**RE: Gold Hill Mill; DRMS File No. M-1994-117: Adequacy Review No. 1 (AM 01)**

This is the Colorado Milling Company, LLC's Response Letter to the Michael Cunningham's Adequacy Review of the Application for an Amendment to the Gold Hill Mill Limited Impact 110 (2) Permit No. M-1994-117, to formally add the previously permitted Left Hand Creek Pump Station, Gold Hill Mill Pipeline, and the Times Mine adit portal to the affected land boundary of the Gold Hill Mill Permit. These three features are collectively referred to as the Gold Hill Mill Waterline in this Response Letter. In order to ensure that the responses to the Division of Reclamation, Mining and Safety's request for additional information and clarification can be properly reviewed, the responses are set out below each of Michael Cunningham's Adequacy Review comments. A separate cover letter for each of the responses that require additional material is attached to this Response Letter.

# TIMES MINE GOLD HILL, COLO.

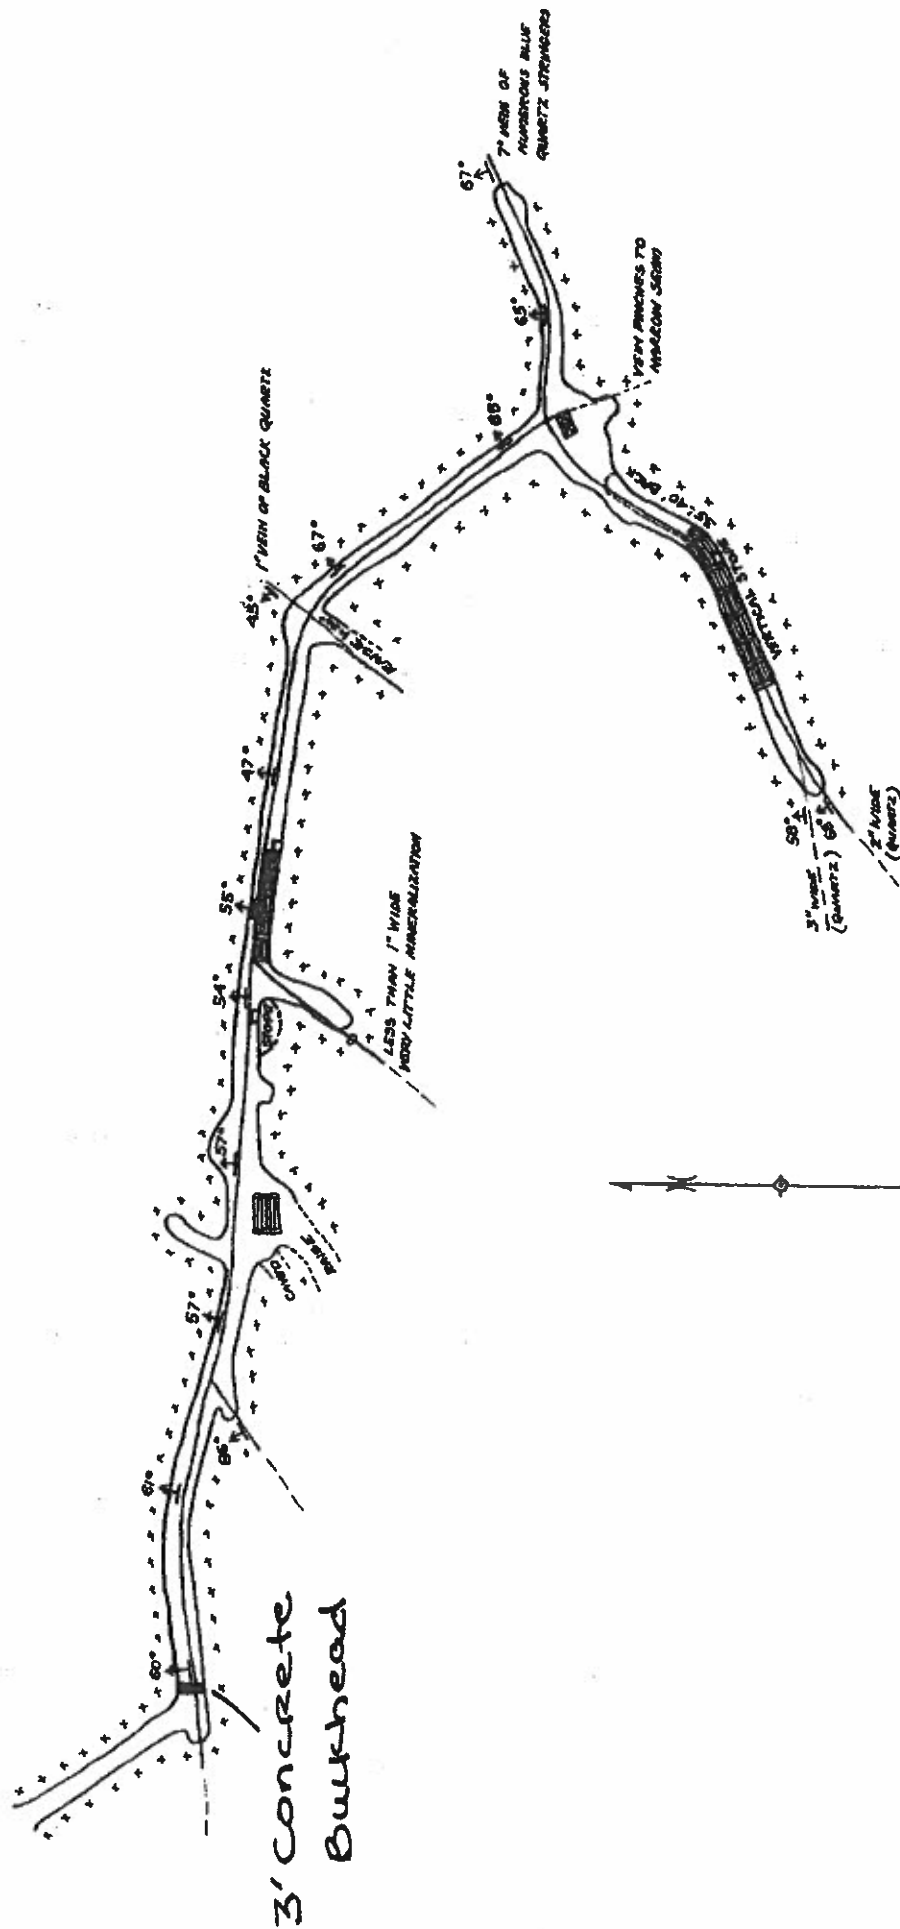
- a) Specify the total volume of water which can be stored in the underground workings of the Times and Wynona Mines.
- b) Provide a detail drawing which depicts all portions of the Times and Wynona Mines which would be used to store water and which shows how the Times and Wynona Mines are connected.
- c) Provide a description of how water will be discharged into the mine and specify where within the Times Mine the water will be discharged. The description shall account for any supporting infrastructure associated with the delivery of water.

- b) The underground mine workings in the Times Mine were mapped by Russell R. McLellan in 1947. It is attached to this Response Letter. The underground mine workings in the Wynona Mine were mapped by A.E. Reardon in 1934 and confirmed by Russell R. McLellan in 1947. A detailed drawing of the Wynona Mine is attached to this Response Letter.

Times Mine Adit  
Concrete Bulkhead

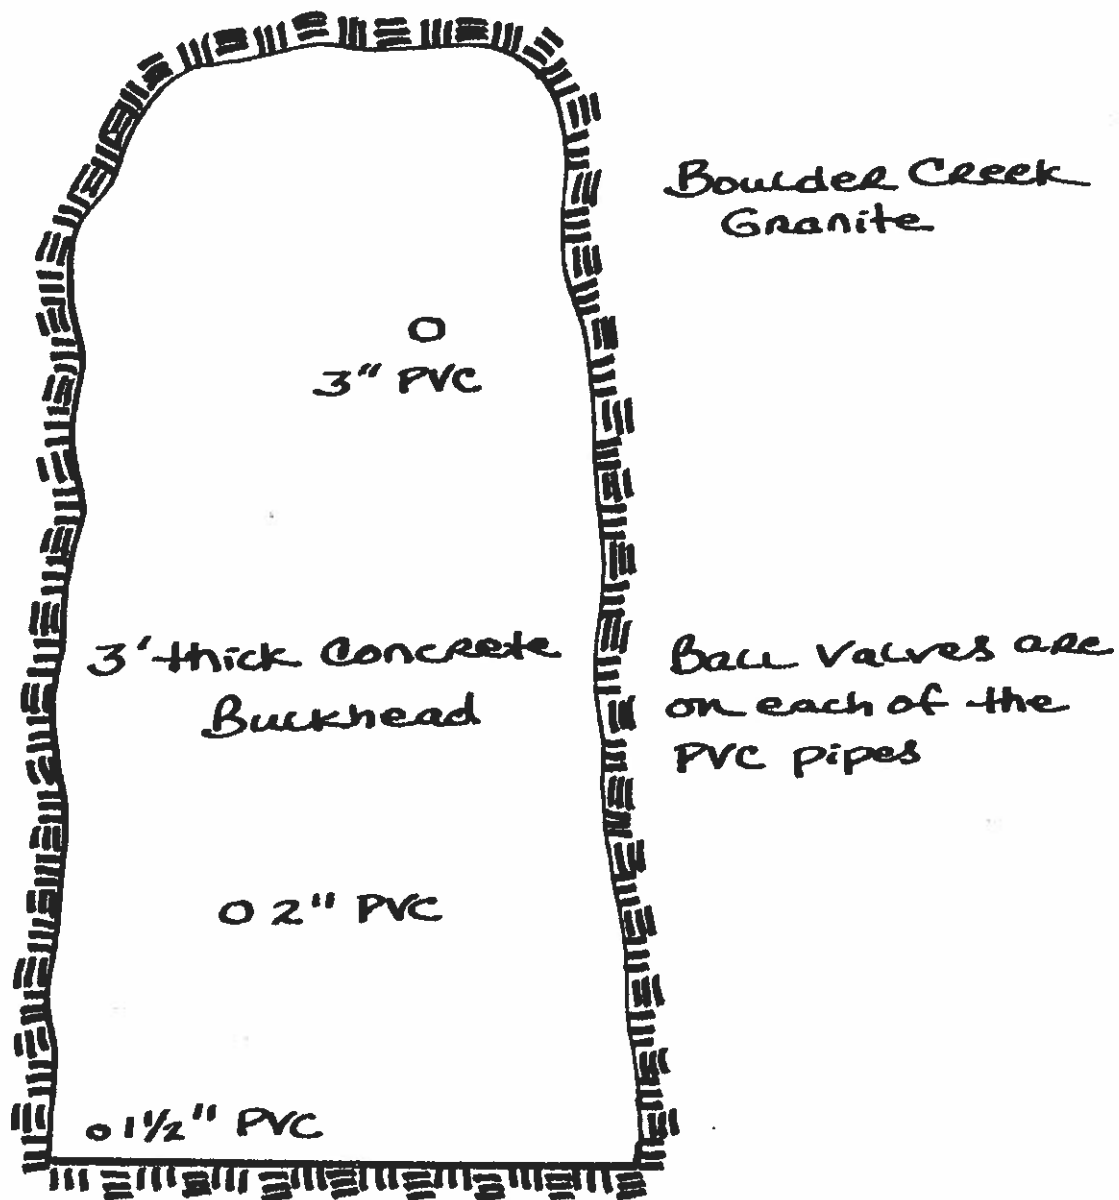
23. The approved Reclamation Permit references a bulkhead within the Times Mine. A review of the permit file found the Division does not have any information about the bulkhead. Please confirm there is a bulkhead within the Times Mine and provide a detail drawing of the bulkhead, a description of how the bulkhead was constructed, and specify where within the Times Mine portal the bulkhead is located.

**CMC Response:** The bulkhead was constructed fifty-four (54) feet behind the original portal of the Times Mine adit, which was driven in solid country rock. The Times Mine bulkhead is now situated one-hundred (100) feet from the metal door of the five (5) foot diameter galvanized steel culvert that provides a safe and secure entrance into the Times Mine. The bulkhead is three (3) feet thick and was constructed of concrete and rebar in a wooden form in 1987. There are three PVC pipes set within the concrete bulkhead. One is a three (3) inch intake pipe situated in the upper right hand portion of the bulkhead. Another, two (2) inch pipe is situated in the lower middle of the bulkhead. A third one and one half (1 1/2) inch pipe is situated in the lower left hand portion of the bulkhead. All these pipes are closed with ball valves, and none of them are leaking water.
